**MEMORANDUM PUBLIC WORKS – COUNCIL MEMO NO. PWE08-017**

**SUBJECT:** ORDINANCE NO. 3932 AMENDING SECTION 43-5.1 OF CHAPTER 43 OF CHANDLER CITY CODE RELATING TO THE CITY OF CHANDLER STANDARD SPECIFICATIONS AND DETAILS

**SUBJECT:**        May 2008 Amendment to the Engineering Standard Details and Specifications (2007 Edition)

DETAIL NO. <b>C-210</b> NTS	 CITY OF CHANDLER STANDARD DETAIL	<b>RESIDENTIAL COLLECTOR STREET          TYPICAL CROSS SECTION</b>	APPROVED: _____ CITY ENGINEER DATE: _____	DETAIL NO. <b>C-210</b> NTS
-----------------------------------	---	--	---	-----------------------------------

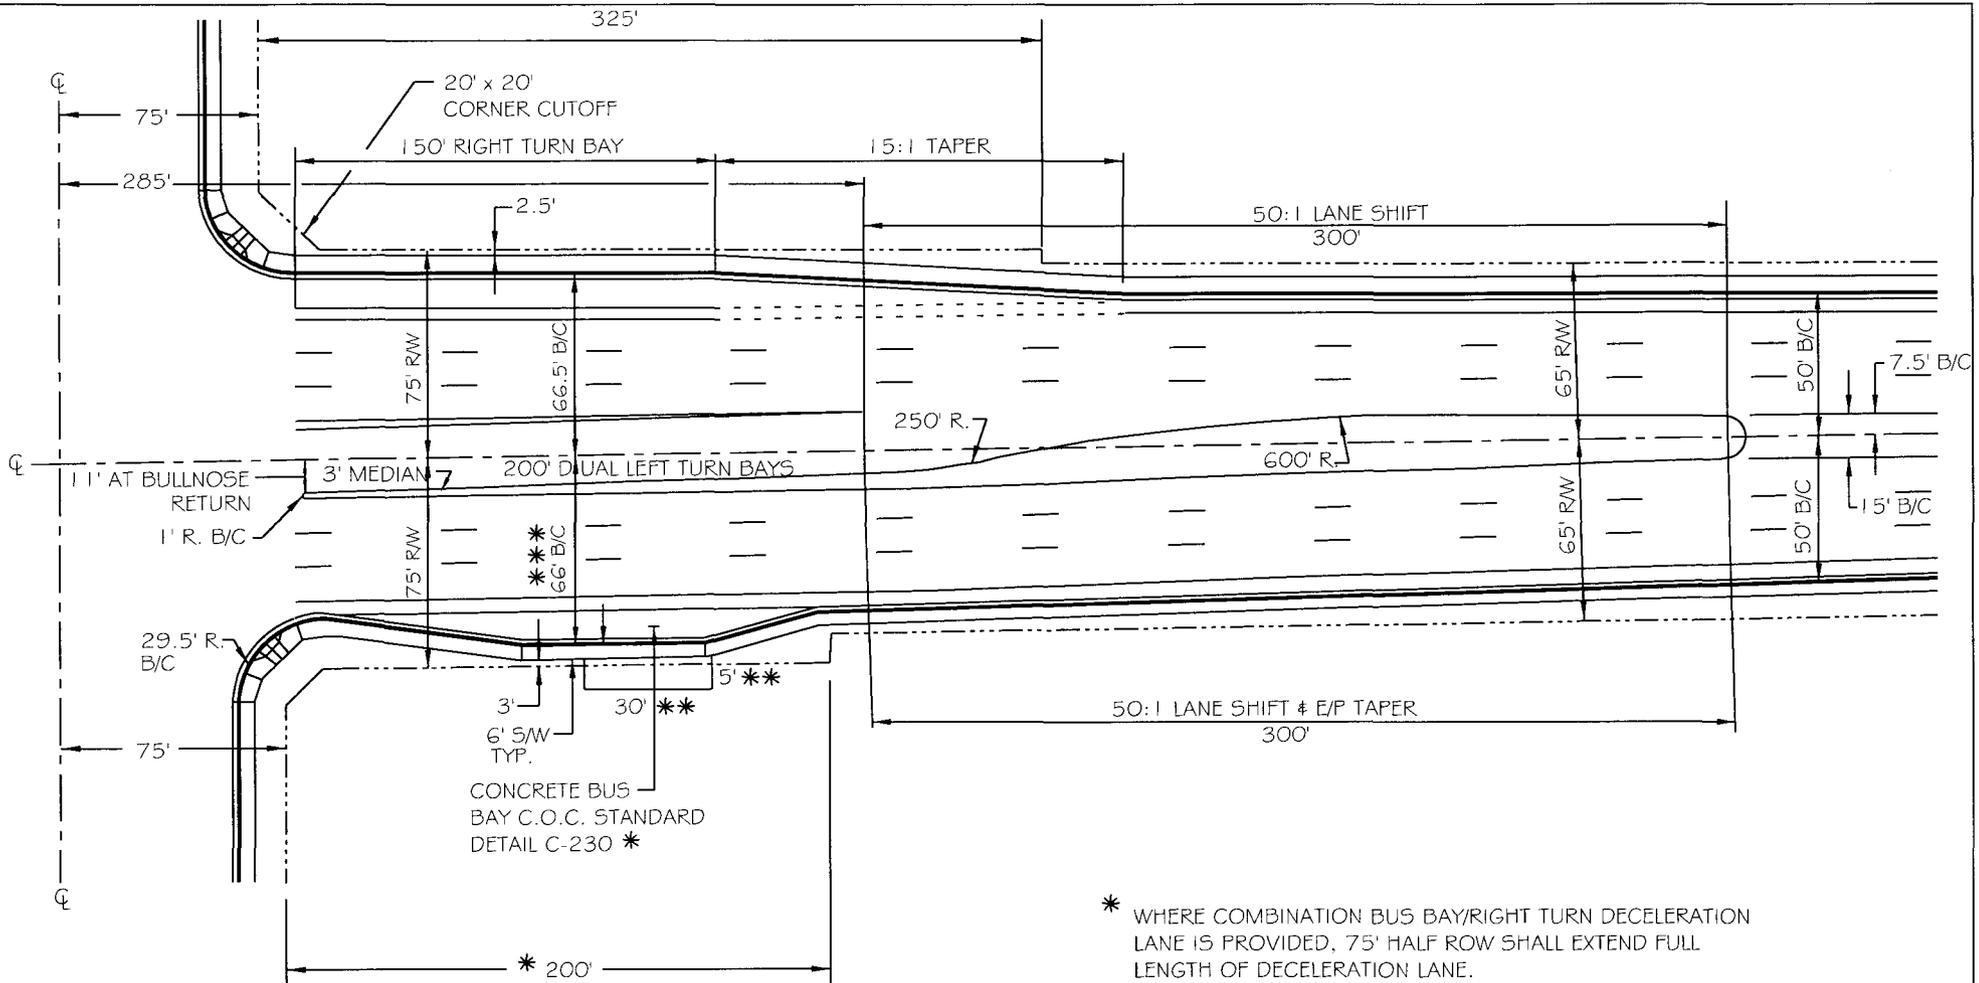
- Detail C-210 - revised cross section dimension from 21' B/C to 22.5' B/C.
- Detail C-223 (Pg 2) - revised median bullnose radius dimension from 2' B/C to 1' B/C.

**"LEFT IN ONLY" MEDIAN DESIGN**  
**16' WIDE MEDIAN**

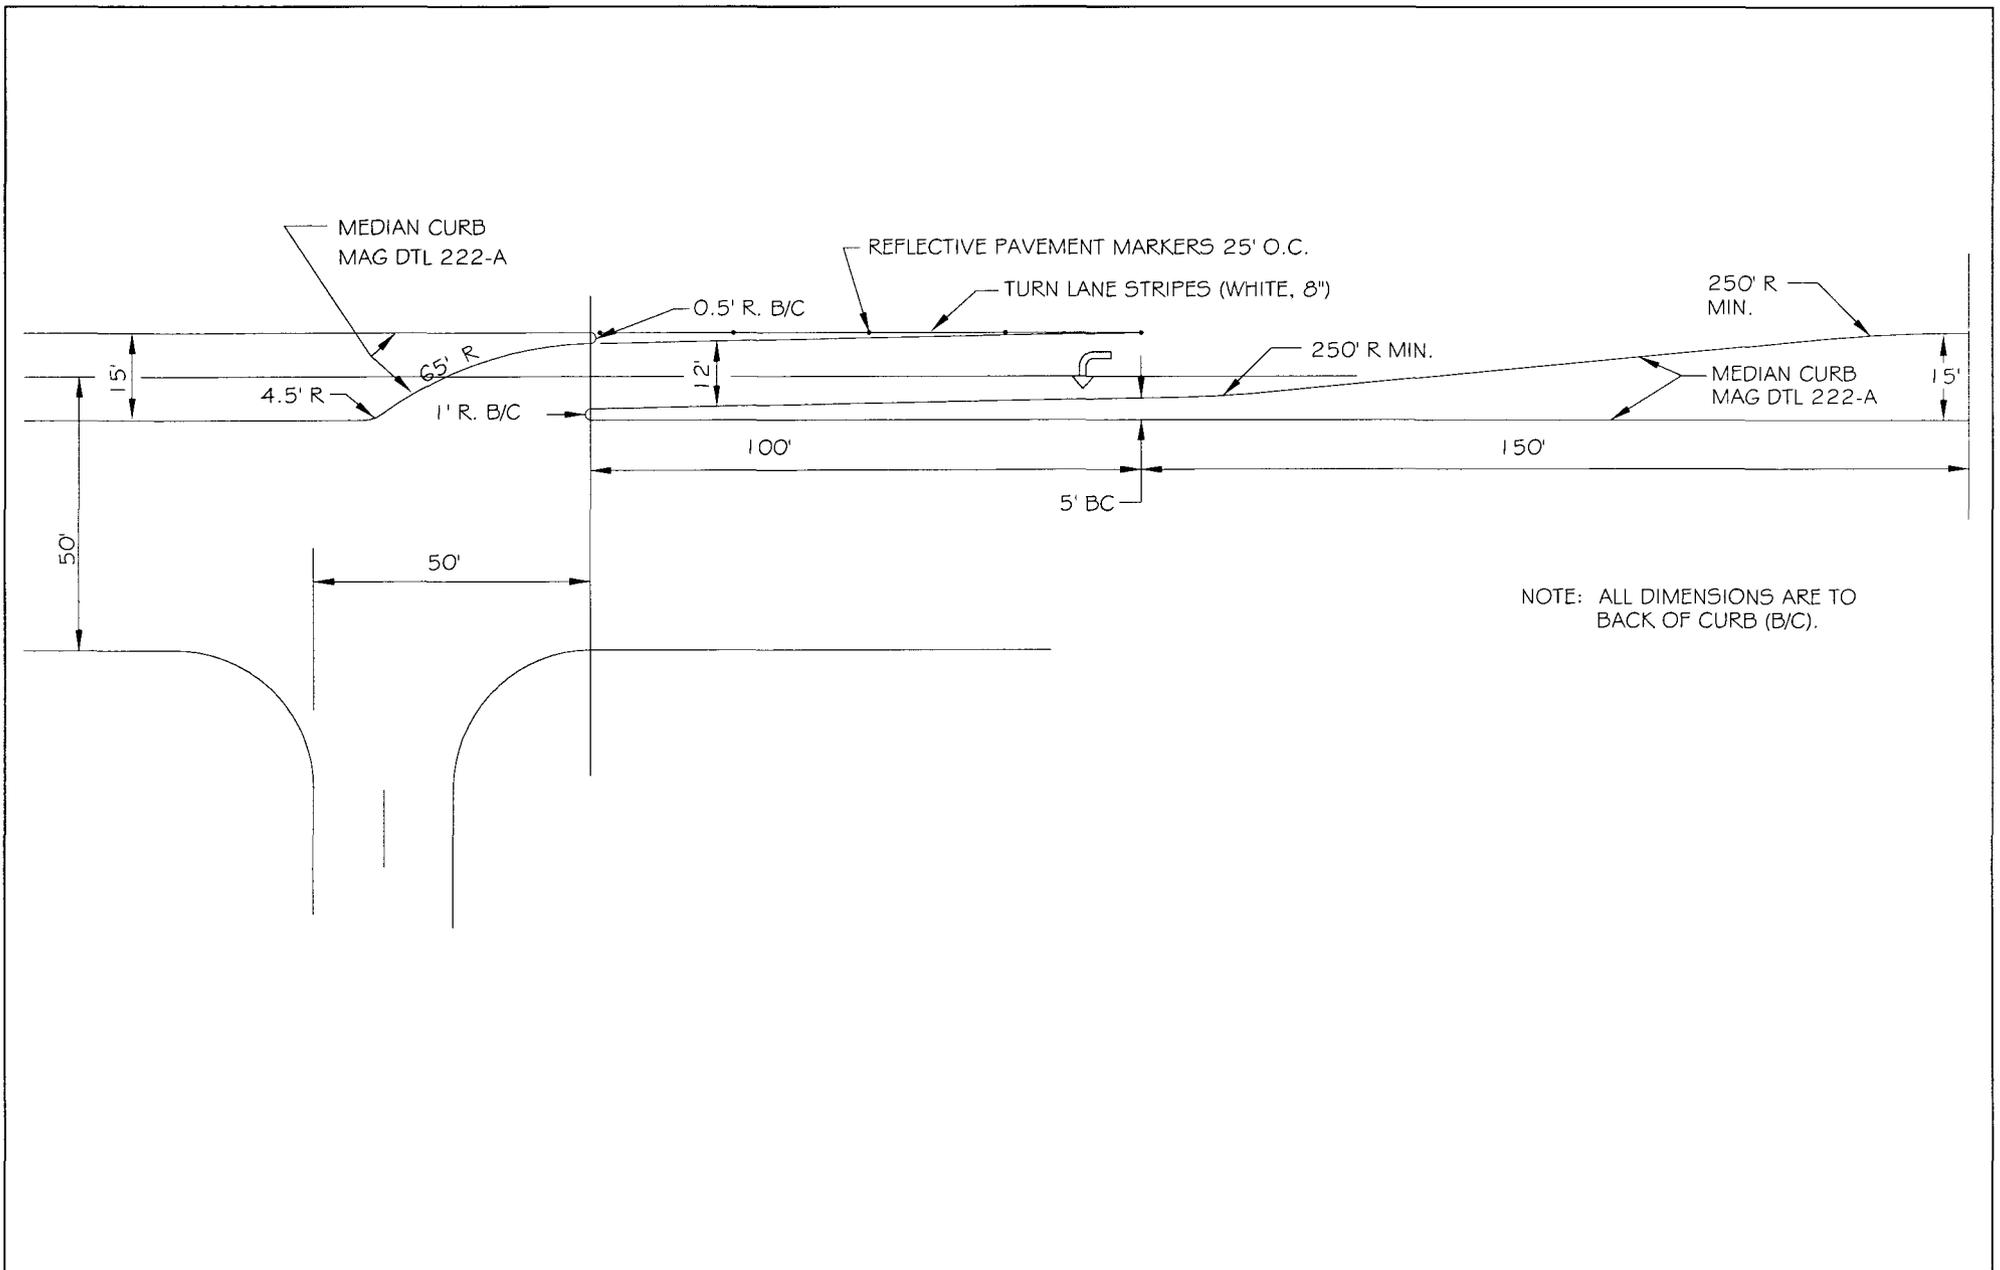
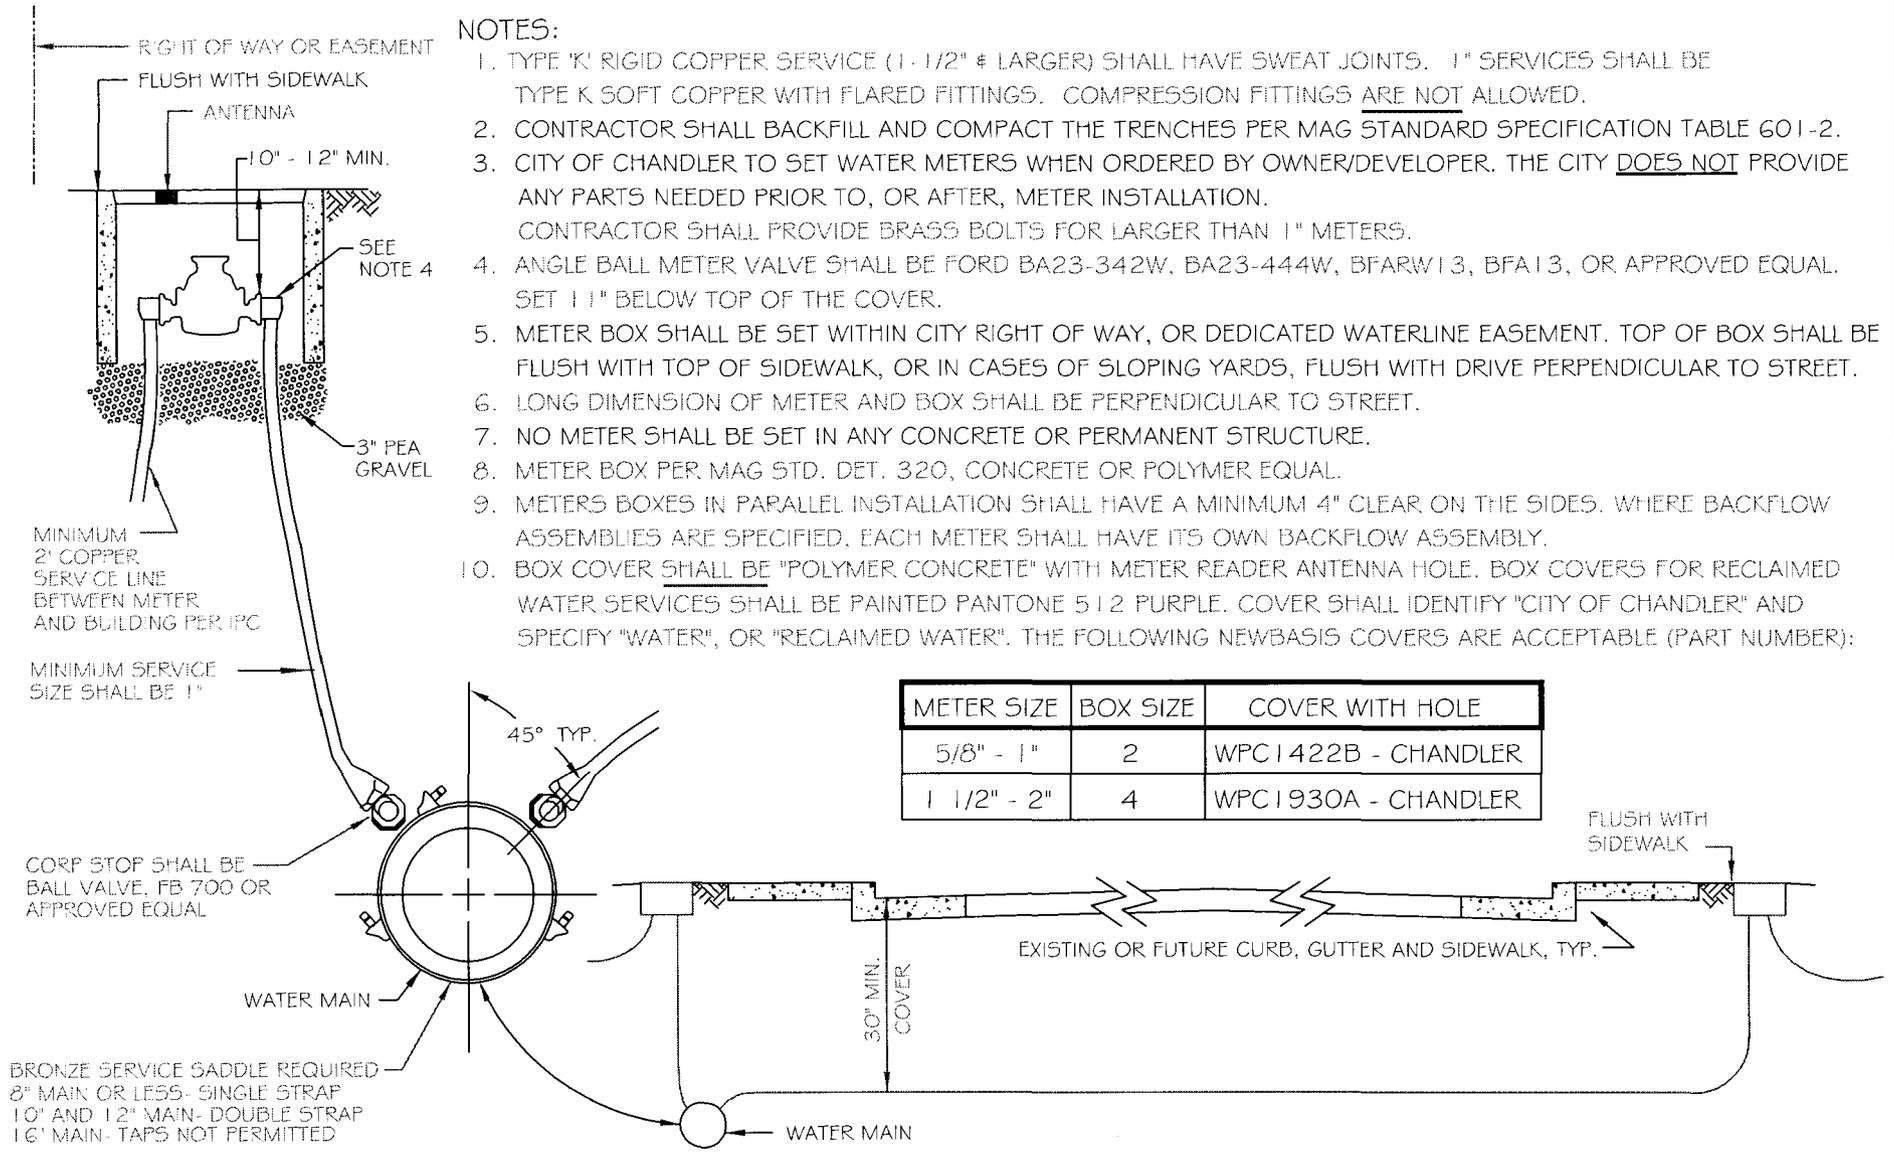
- Detail C-226 - revised median bullnose radius dimension of 1' B/C to 0.5' B/C.
- Detail C-301- graphical revisions for clarification, corrections to notes, updates for a new a polymer meter box and cover and new signal antenna used by Utility Services to read meter usage.

DETAIL NO. <b>C-404</b> PAGE 3 OF 12	 CITY OF CHANDLER STANDARD DETAIL	<b>2" RECLAIMED WATER          IRRIGATION SERVICE LINE          INLINE PUMP TYPE</b>	APPROVED: _____ CITY ENGINEER DATE: _____	DETAIL NO. <b>C-404</b> PAGE 3 OF 12
--	--	--	---	--

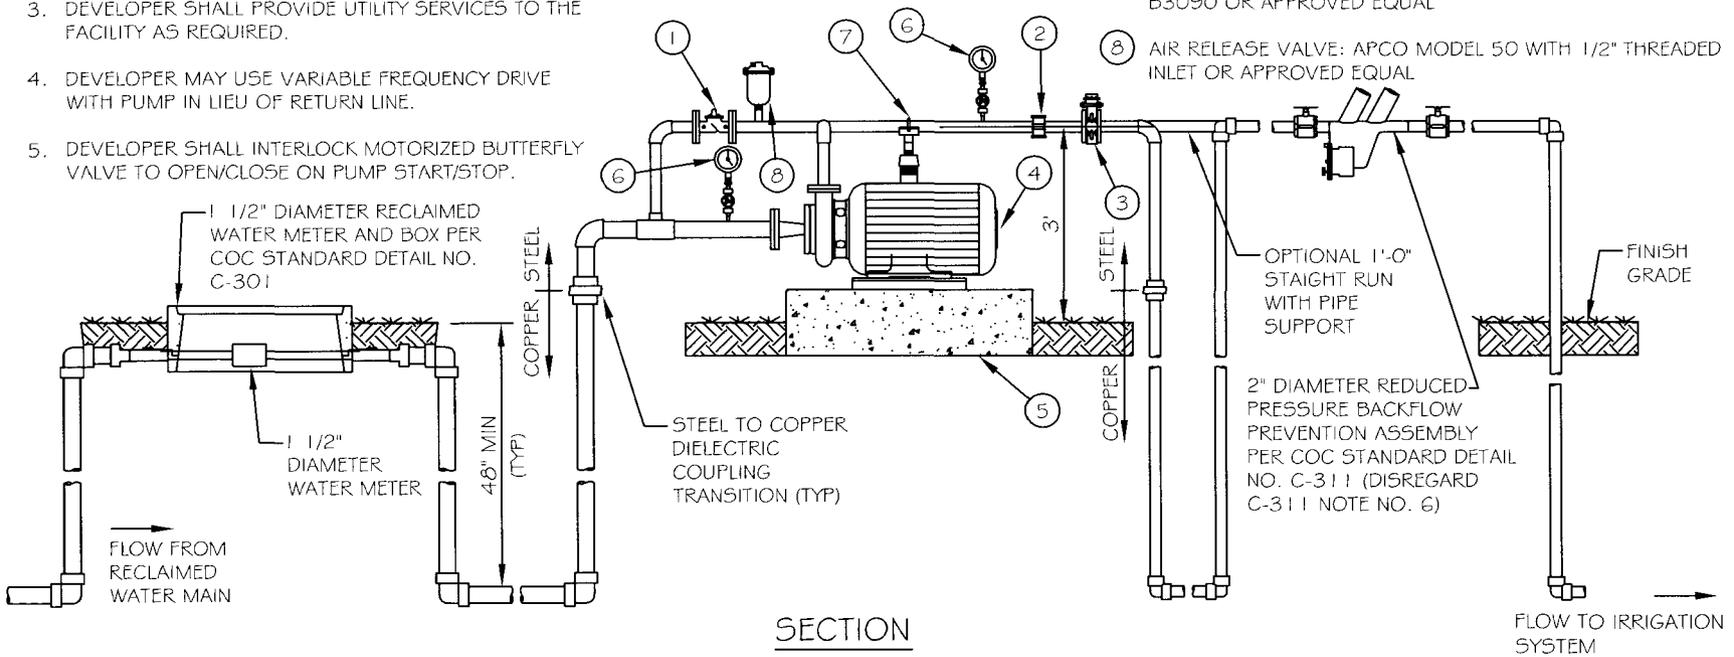
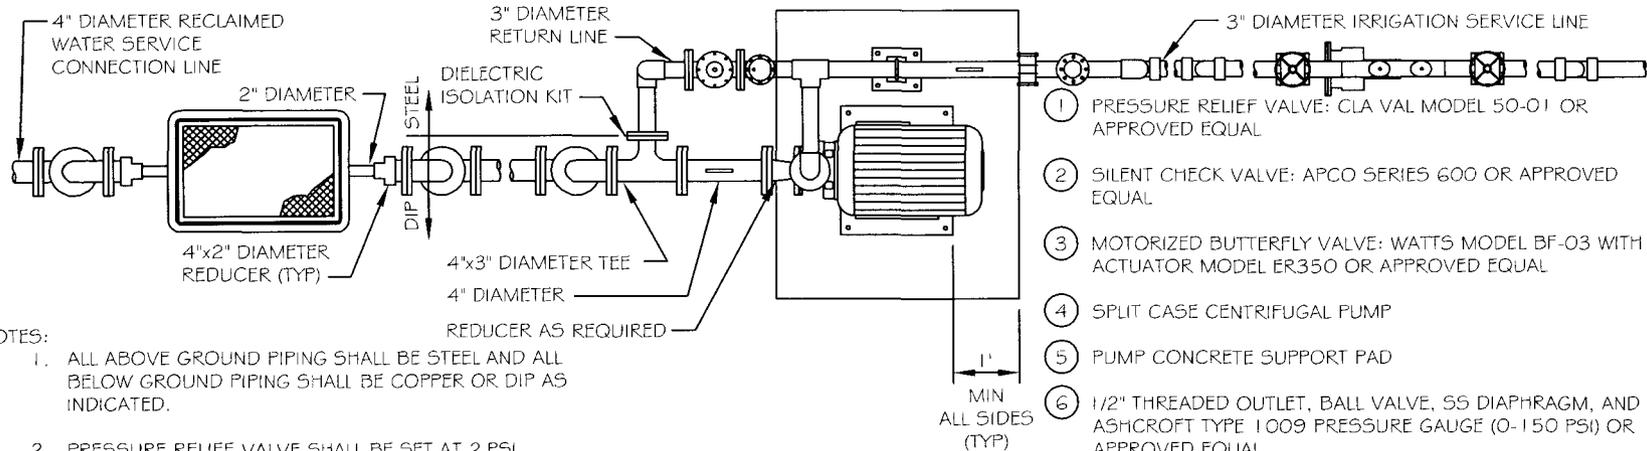
- Detail C-404 (PG 1-12) – revisions and additional standard details needed for reclaimed water services to accommodate various meter sizes and flow requirements.
